ADDENDUM # 2

ITB # 2025-861

HARTMAN PARK FIELD LIGHTING

RE: Hartman Park Foundation Review
GEOMAT Project No. 244-4807

SHEET NO.
S1

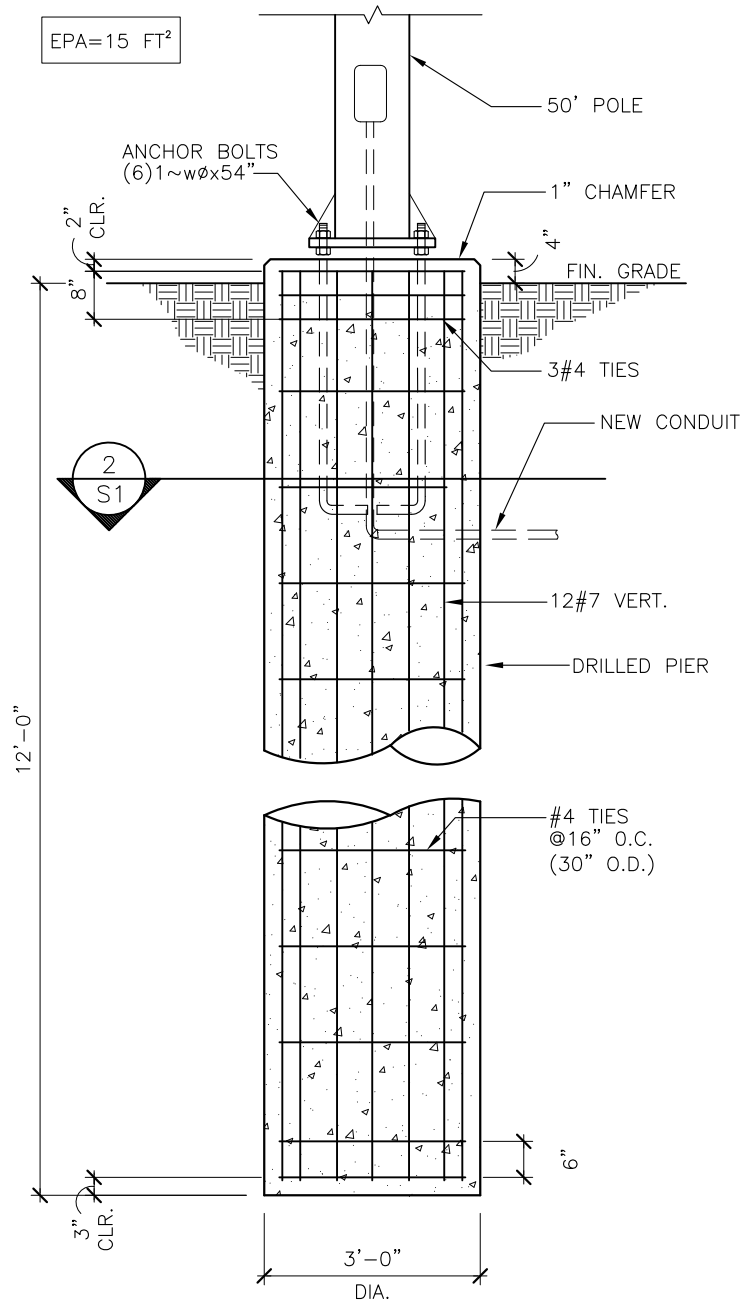
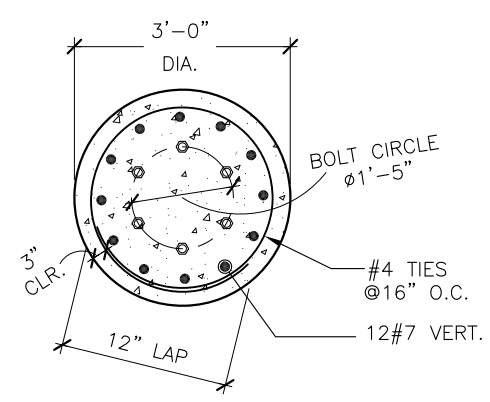
As per your request, GEOMAT has reviewed the proposed drilled pier foundation designed by the Sadler Group sealed and dated 2/13/24 using the information GEOMAT provided in the attached geotechnical report for the Williams Arroyo Gabion Wall Repair Project #232-4570 dated October 30, 2023. Two of the proposed lights are located in the vicinity of Bores B-1 and B-2 from the referenced report. Loads and reactions provided by the Sadler Group were utilized for the review.

Based upon our analysis, it was determined that the foundations as designed by the Sadler Group will be satisfactory based upon the conditions encountered in our borings. For our analysis, we assumed that the gabion slope stabilization will be in place to resist potential blowout and scouring. We further recommend that the lights/foundations should be constructed no closer than ten (10.0) feet from the back face of the gabion retaining wall. It is assumed if there is geofabric designed for the proposed gabion wall, it could potentially be located and interfere with the location at which the light/foundation is proposed. Construction and placement of the geofabric shall follow manufacturer's recommendation when there are obstructions and penetrations in the geofabric.

Based upon the boring data, it should be anticipated that soft, wet soils and potentially groundwater will be encountered. If caving occurs or "slough" from the surface falls into the borehole after placement of the reinforcement cage, the reinforcement cage shall be removed, the bottom cleaned out, and reinforcement cage reinserted. The use of drilling slurry or casing may be required should groundwater be encountered. Tremie methods of concrete placement as described below may aid in constructing the shaft.

- Drilled shafts shall be cleaned with a clean-out bucket, immediately before concrete placement.
- The tremie or pump pipe shall have watertight joints.
- During the initial concrete placement, the concrete tremie or pump pipe shall be extended to the bottom of the drilled shaft before concrete placement.

- During placement of concrete, the bottom of the pipe shall be maintained below the top of the concrete at all times. If the seal is lost, the pipe shall be re-inserted, and the operation restarted.
- Sufficient embedment of the tremie or pump pipe in concrete shall be maintained throughout concrete placement to prevent re-entry of water. The minimum embedment depth shall be 5 feet.
- The first-placed portion of concrete flow that comes to the top of the shaft shall be wasted, as determined by the Geotechnical Engineer.
- Under no circumstances shall concrete be allowed to free fall through water or drilling fluid.
